PERFORMANCE SPECIFICATION SHEET

MICROPHONE ASSEMBLY, M-169A/AIC

This amendment forms part of MIL-PRF-26542/12B, dated 11 February 1999,
And is approved for use by all Departments and Agencies of the Department of Defense.

FIGURE 2. Frequency response envelope for microphone element M-101/AIC ground level.

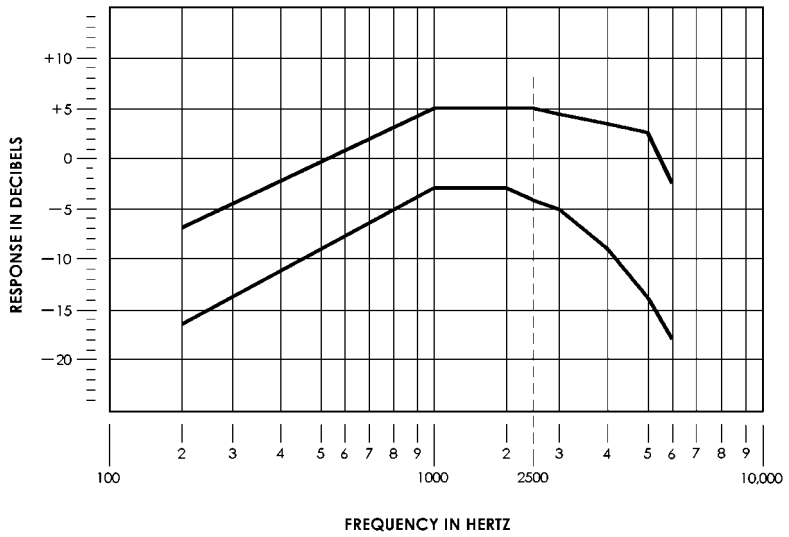
Figure 3: Delete and substitute:

Frequency points (Hz)	200 Hz	1,000 Hz	2,000 Hz	2,500 Hz	3,000 Hz	4,000 Hz	5,000 Hz	6,000 Hz
Upper limits (dB)	-7.00	5.00	5.00	5.00	(4.34) 1/	(3.31) 1/	2.50	-2.50
Lower limits(dB)	-16.50	-3.00	-3.00	(-4.10) 1/	-5.00	-9.00	(-13.96) 1/	-18.00

1/ dB limits between key break point are calculated.
